**Subject: Mass DEP File # 301-1397 - Revised Site Plans
86-92 Boston Post Road
Sudbury, MA**

**Re: Invasive Plant Protocol
86-92 Boston Post Road, Sudbury**

PROPOSED SITE PLAN
 OF
 86-92 BOSTON POST ROAD
 IN
 SUDBURY, MA

Figure (Invasive Plant Areas)

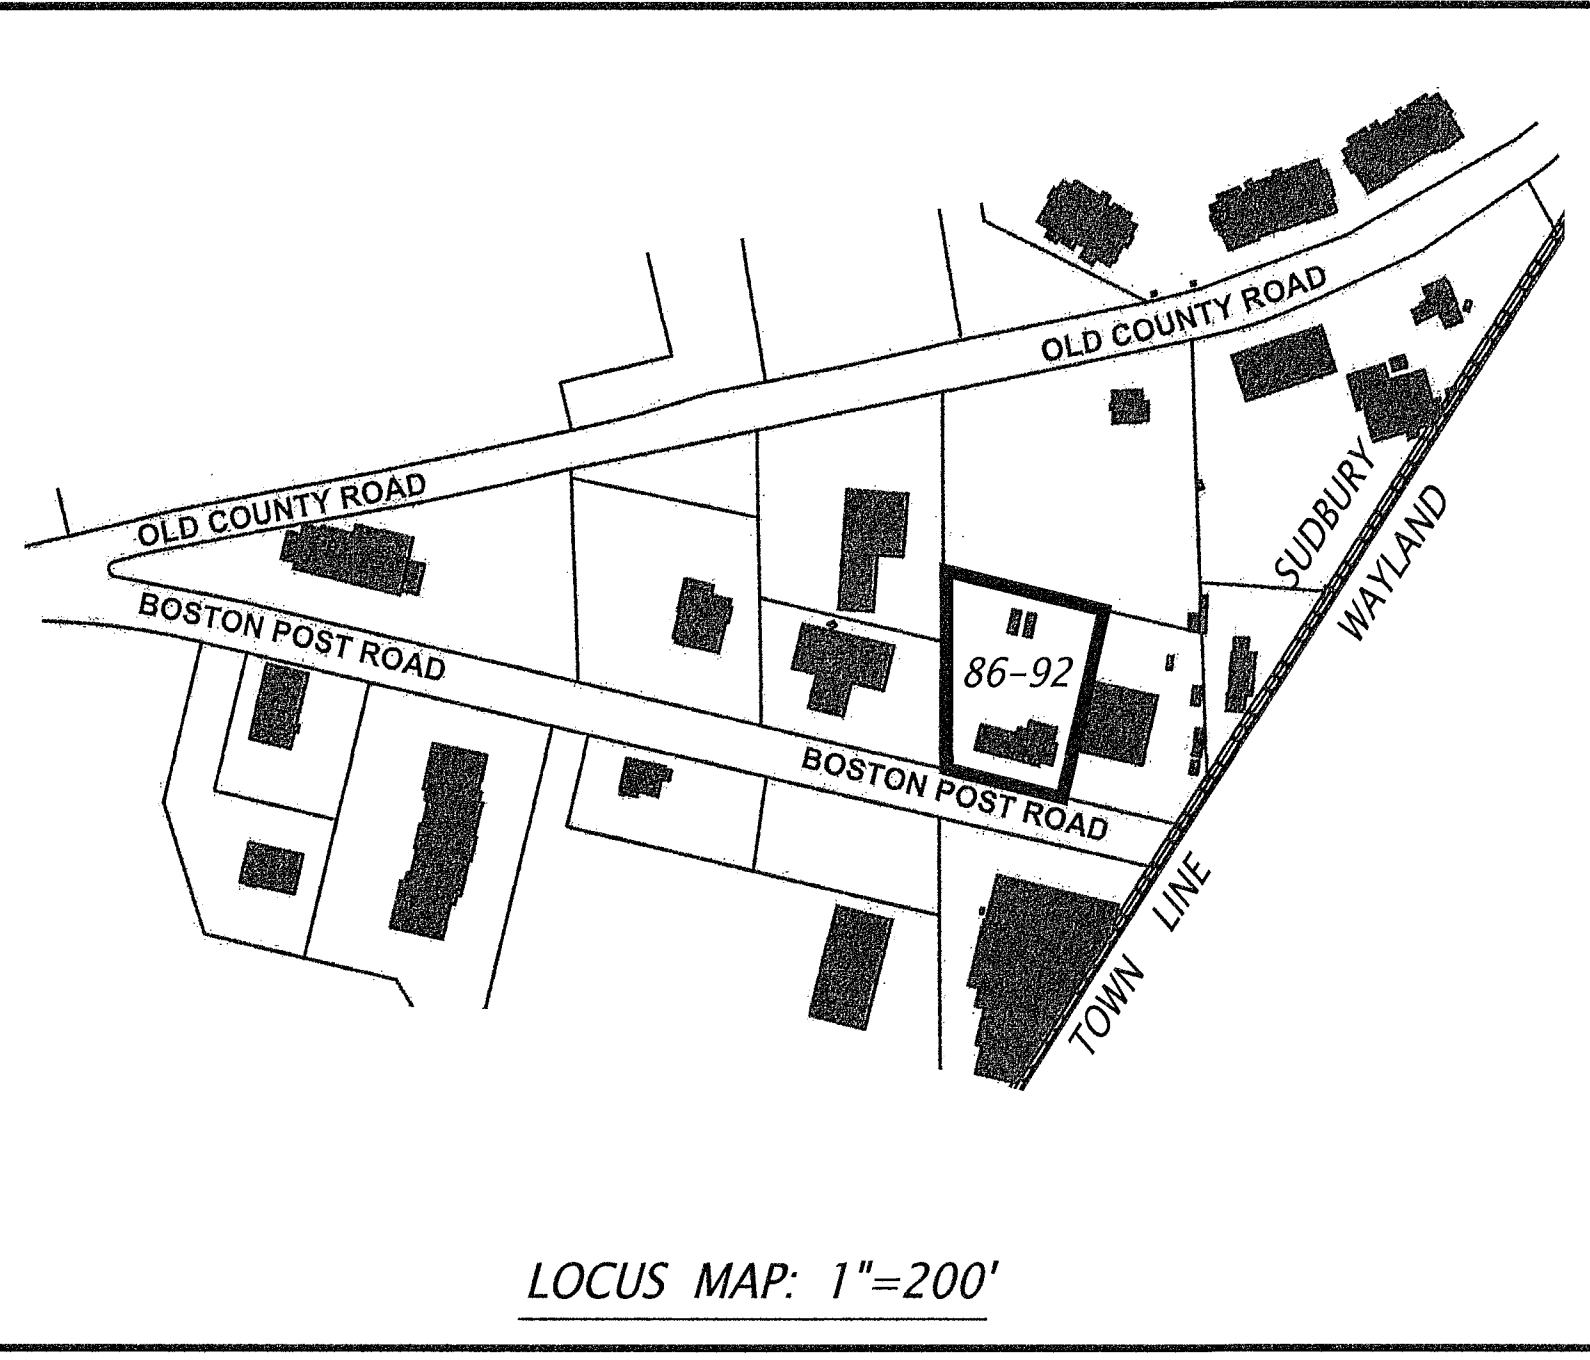
3. Mitigation to offset the introduction of impervious surfaces has not been developed. The applicant was asked to look at the area outside of their limit of work to clean up trash and debris that has been dumped in the wetland and to conduct invasive species management and replanting to mitigate for the project footprint.

Response: An Invasive Species Management Plan has been prepared by the project Wetland Scientist. A copy has been attached for review.

In addition to the invasive plant removal, the applicant proposes to seed the area at the rear of the lot (see Figure), which has a mix of gravel and loam substrate and lacks vegetation. This area will be restored by applying a native seed mix (New England Erosion Control/Restoration Mix for Dry Sites) per the recommended application rates.

CONSTRUCTION PLAN
 SCALE: 1"=20' SHEET 2 OF 6.

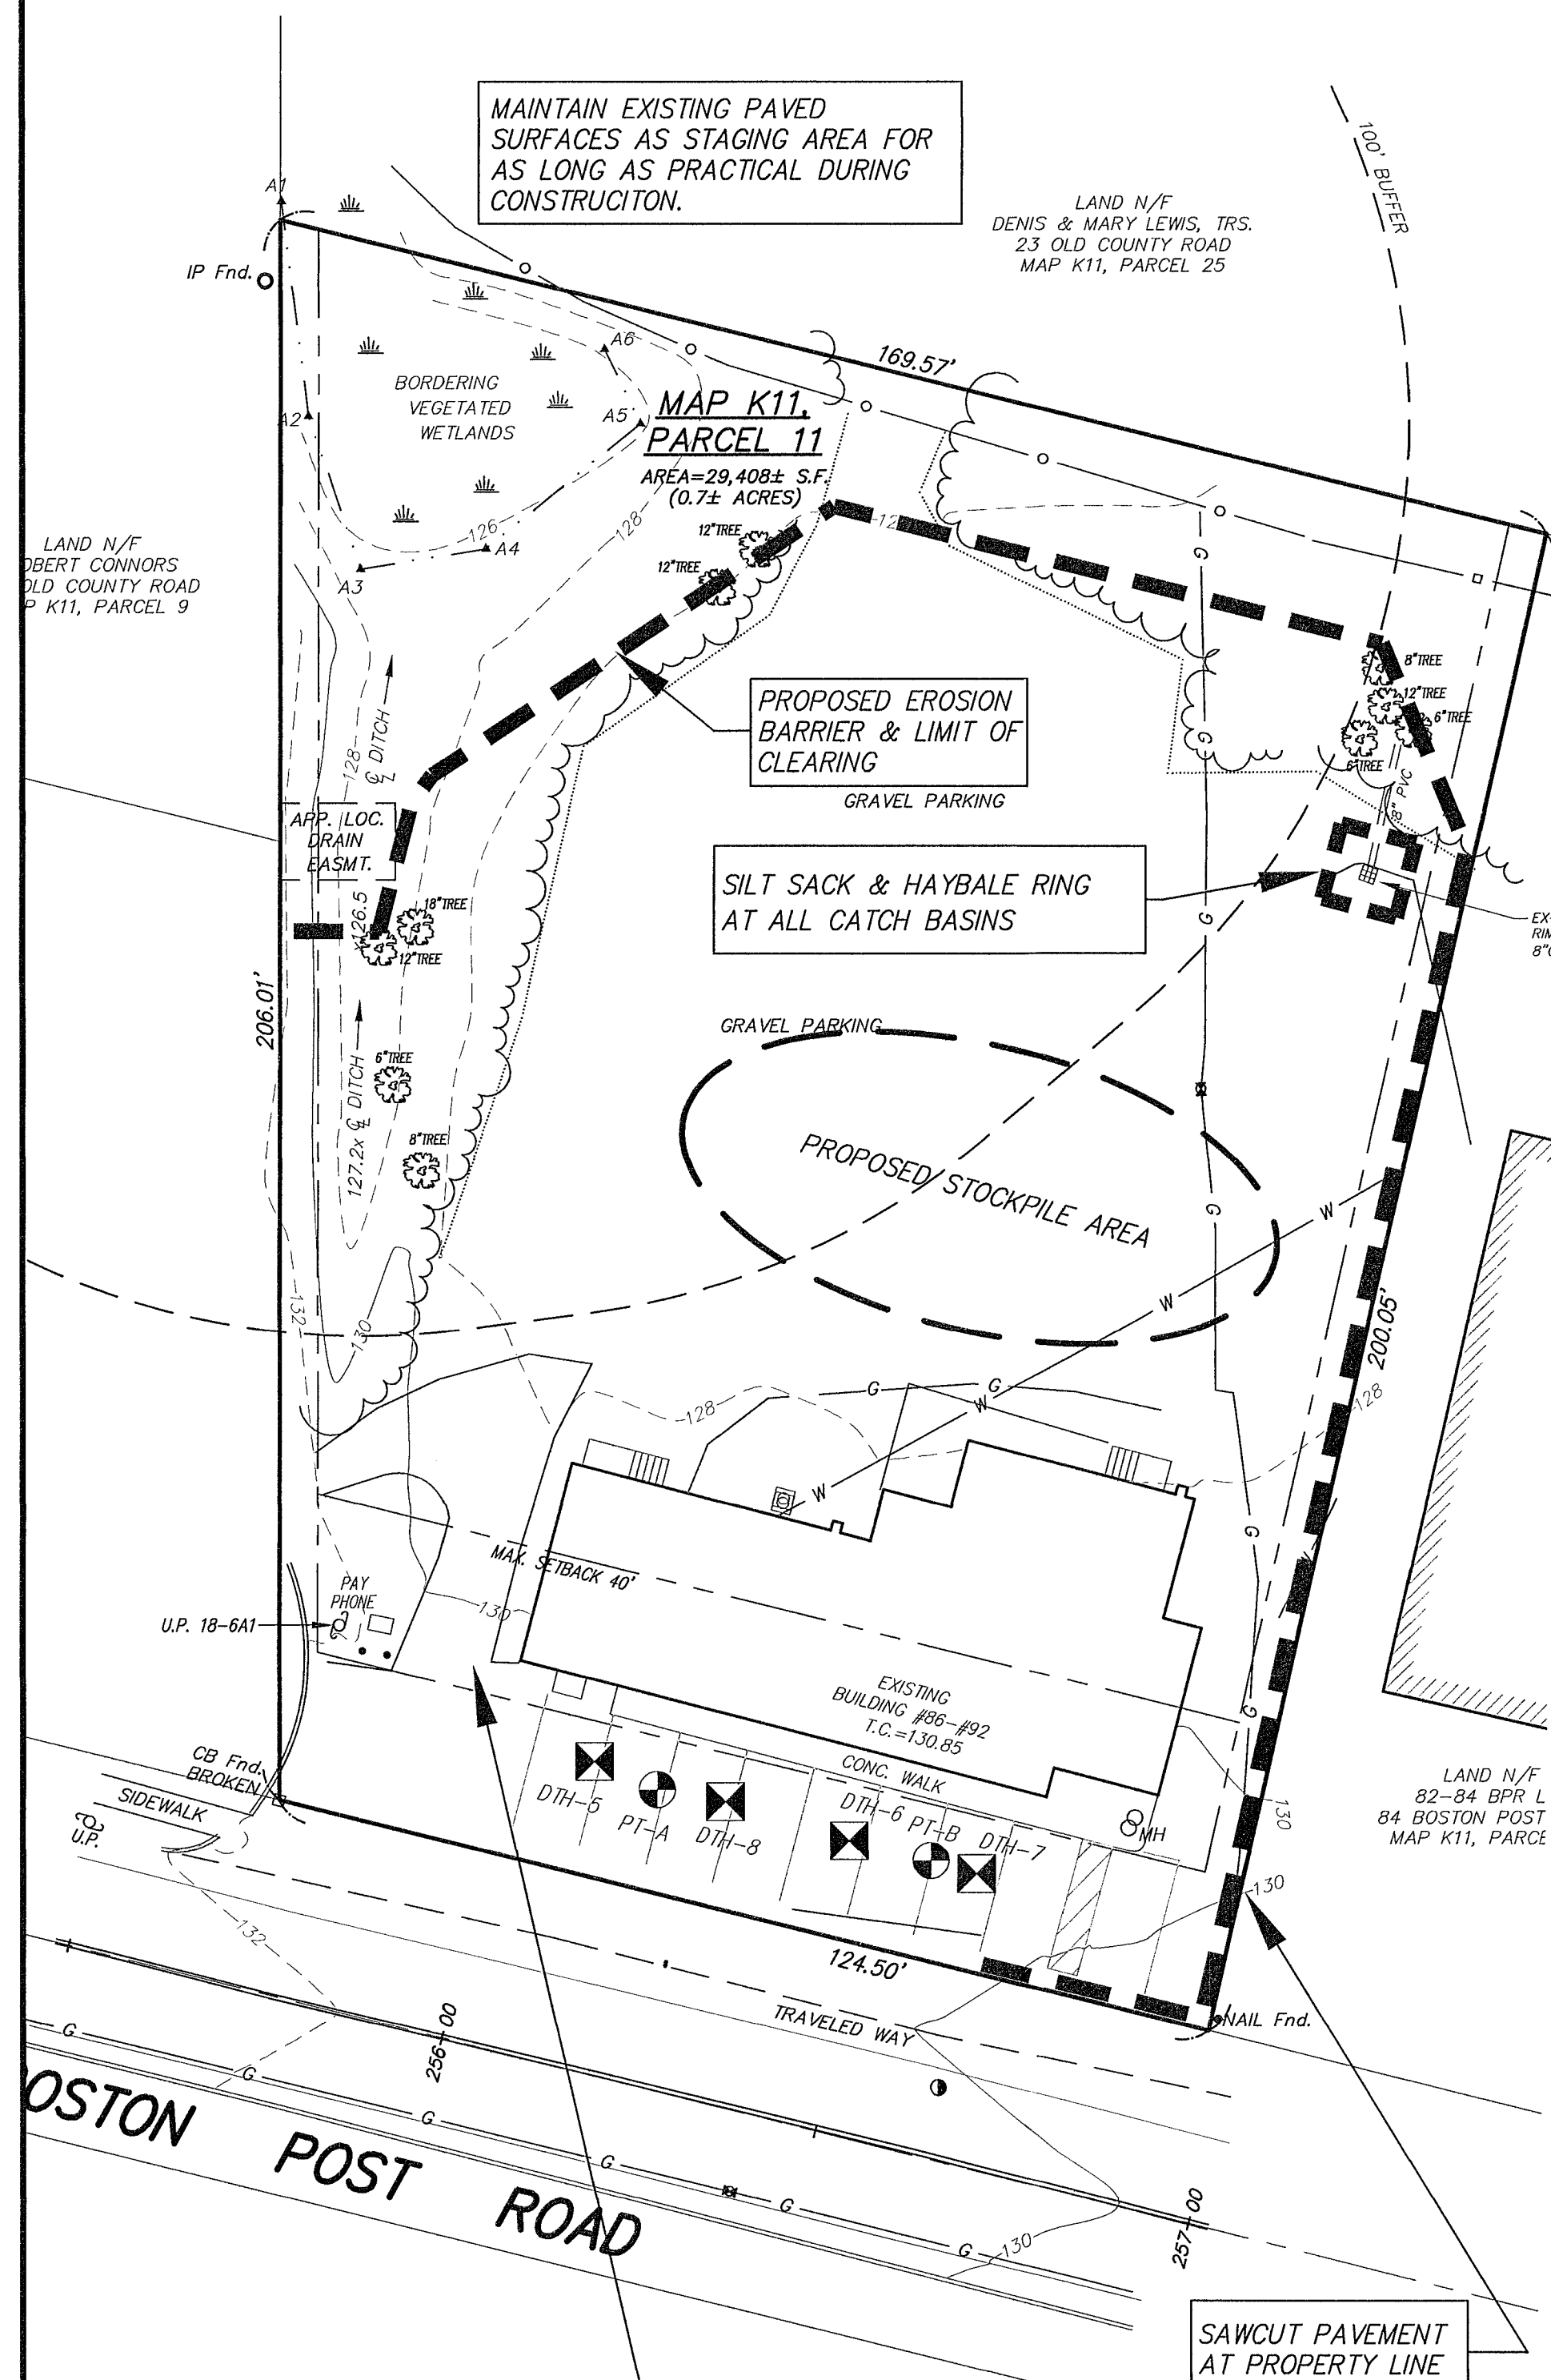
1. Secondary containment for the building. The applicant stated that the building foundation will be surrounded by a rubber membrane to contain any potential leaks from the business operations. The plans should reference this element.

Response: The secondary containment at the tank room has been noted on the site plans. The details would be provided on the architectural plans submitted at the time of building permits.
